Technical Service Bulletin

Clutch Pedal Noises

Some 2005 – 2023 model year Tacoma vehicles equipped with a manual transmission may exhibit a squeak or creak noise from the clutch pedal when it is depressed or released.

Figure 1.

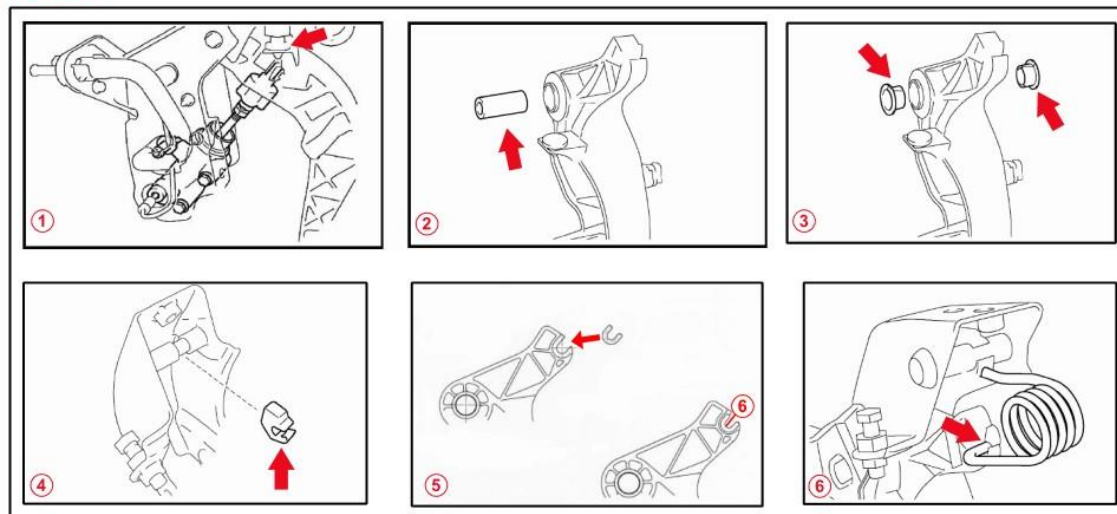
- Apply body grease 08887-02007 where the clutch master cylinder clevis and clutch pedal meet (see callout 1).
- Apply Multi-Purpose grease to the shaft collar and turnover spring contact surfaces as shown in the Repair Manual (see callouts 2 – 6)

1	Apply Body Grease W Where the Clutch Master Cylinder and Clutch Pedal Meet
2	Apply MP Grease to Clutch Pedal Shaft Collar
3	Apply MP Grease to the Two Bushings
4	Apply MP Grease to Clutch Pedal Spring Holder and Clutch Pedal Support

5	Install Bushing on Clutch Pedal Sub-assembly Compression Spring Insert
6	Apply MP Grease to Clutch Pedal Sub-assembly and Compression Spring

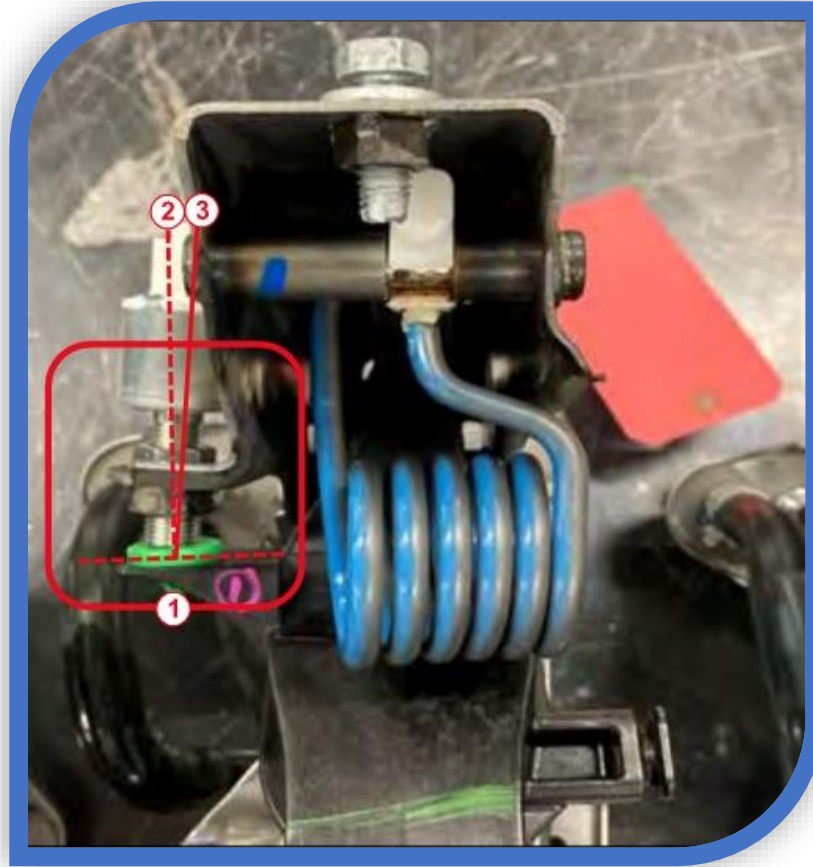
- 3. Inspect the clutch pedal bracket assembly for ANY deformations. Replace the clutch pedal bracket if necessary**

1	Deformation Area
2	Normal Position
3	Position After Deformation
